Application Serial No. 10/657,637
Amendment dated August 9, 2005
Reply to Office Action dated June 14, 2005

Amendments to the Drawings:

REMARKS

FIG. 6

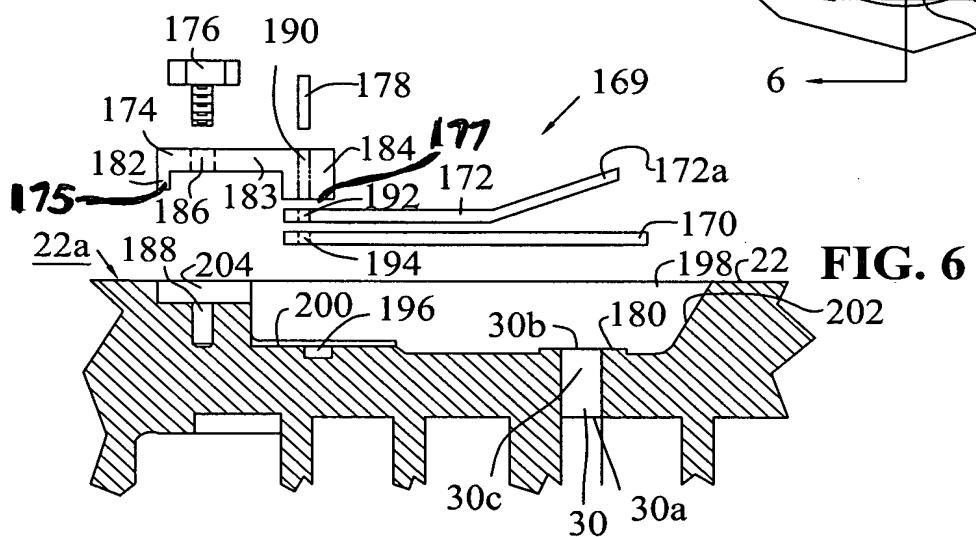
Applicants have amended Fig. 6 to include reference numerals and lead lines for bearing surfaces 175 and 177. Applicants have also amended Fig. 13 to provide a lead line for reference numeral 285.
